# UNITED STATES PATENT AND TRADEMARK OFFICE

APPLICATION NO.	FILING DATE	FIRST NAMED INVENTOR	ATTORNEY DOCKET NO.	CONFIRMATION NO.
10/791,514	03/01/2004	Henri V. Azibert	CTH-302	2753
959	7590	06/21/2006	EXAMINER	
LAHIVE & COCKFIELD 28 STATE STREET BOSTON, MA 02109			LEE, GILBERT Y	
			ART UNIT	PAPER NUMBER
			3673

<b>Office Action Summary</b>	<b>Application No.</b>	<b>Applicant(s)</b>	
	10/791,514	AZIBERT, HENRI V.	
	<b>Examiner</b>	<b>Art Unit</b>	
	Gilbert Y. Lee	3673

## **DETAILED ACTION**

*Examiner's ATTACHMENT A*

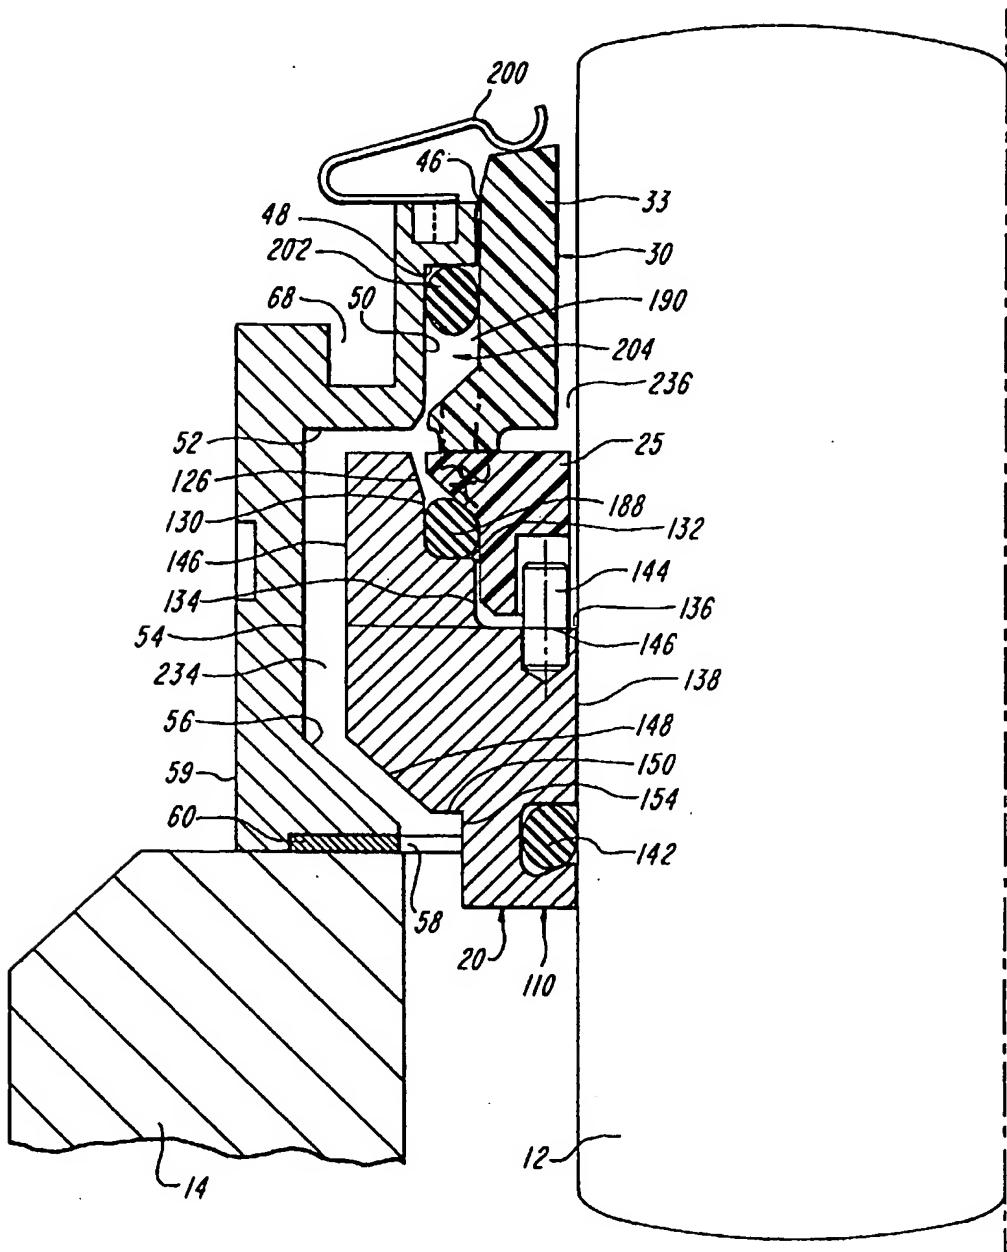
Regarding claim 18, the Clark et al. reference discloses a first piston area (A) defined by an outer edge of the radially extending seal face of one of the seal rings and an axially extending, inner surface of the shuttle member (Fig. 2), and

Regarding claim 19, the Clark et al. reference discloses the first piston area and the second piston area being **about** equal in size (See Examiner's Attachments A & B).

Regarding claim 20, the Clark et al. reference discloses the first piston area and the second piston area being smaller than a contact area of the rotary seal face and the stationary seal face (See Examiner's Attachments A & B).

Regarding claim 37, the Clark et al. reference discloses defining a first radially extending piston area (B) on the rotary seal ring for biasing the rotary seal ring against the stationary seal ring under the first pressure condition (Fig. 2), and

Examiner's ATTACHMENT B

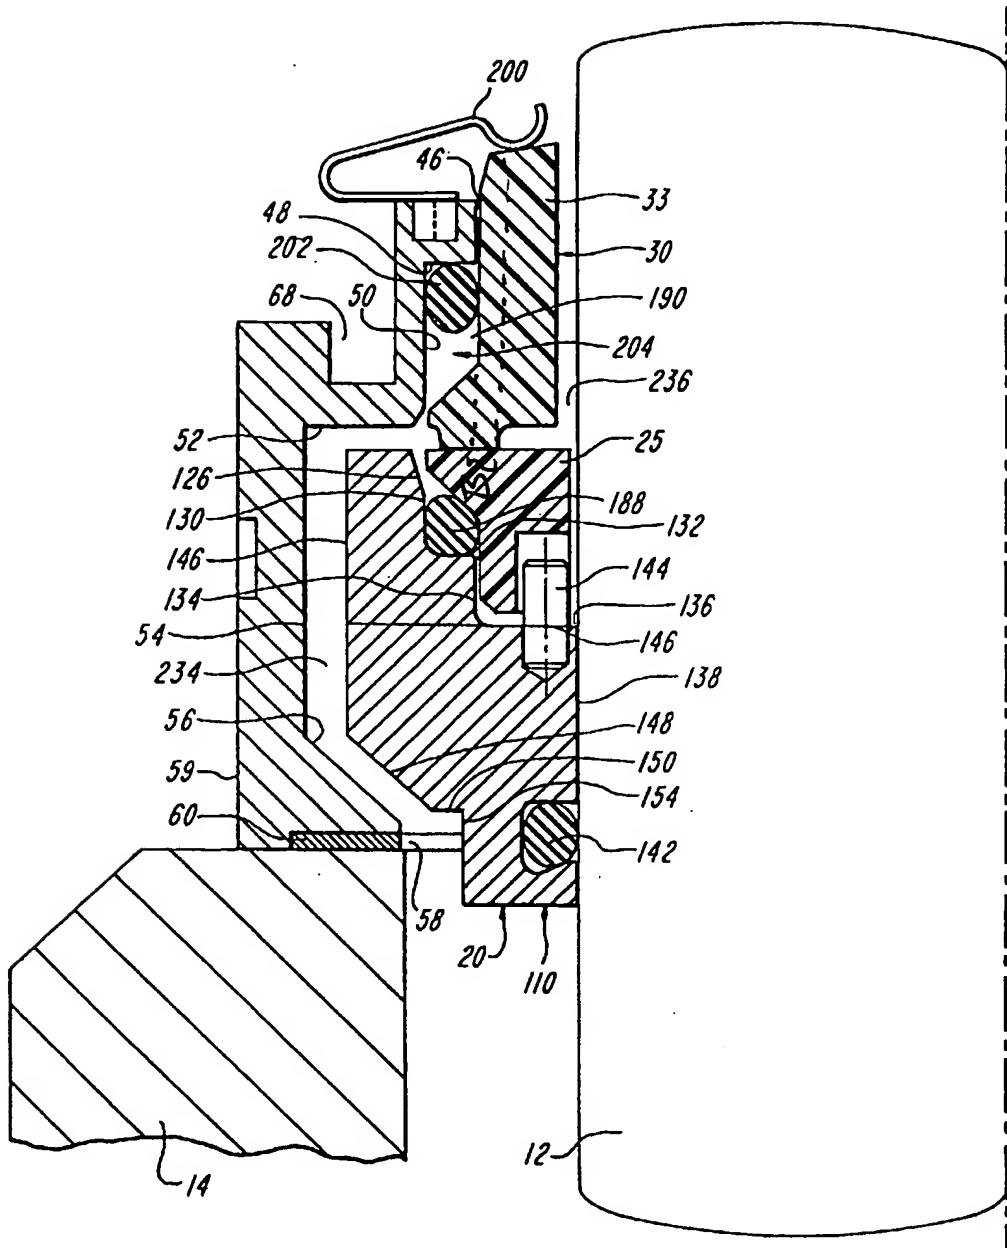
a second piston area (B) defined by an inner edge of the radially extending seal face of one of the seal rings and an axially extending, inner surface of the shuttle member (Fig. 2).

defining a second piston area (A) on the rotary seal ring for biasing the rotary seal ring against the stationary seal ring under the second pressure (Fig. 2).
